BURLINGTON DEVELOPMENT REVIEW BOARD

TO: Development Review Board
FROM: Scott Gustin & Mary O'Neil, Senior Planners
DATE: June 16, 2015
RE: 15-1213SP; 351 North Avenue

Request: Sketch plan review of proposal to convert orphanage building into approximately 63 residential units. Also establish common spaces and assembly space for existing college.

C1.0

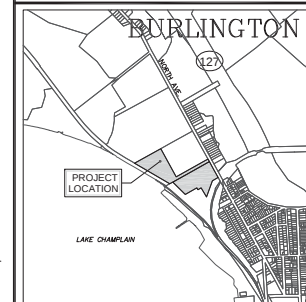
Plan C1.0 defines existing landscaping; Plan L100 proposed conditions. A significant amount of landscaping is proposed, particularly with new tree plantings surrounding and adjacent to the pedestrian walkways. A landscaping plan must be provided identifying species and caliper at the time of application.
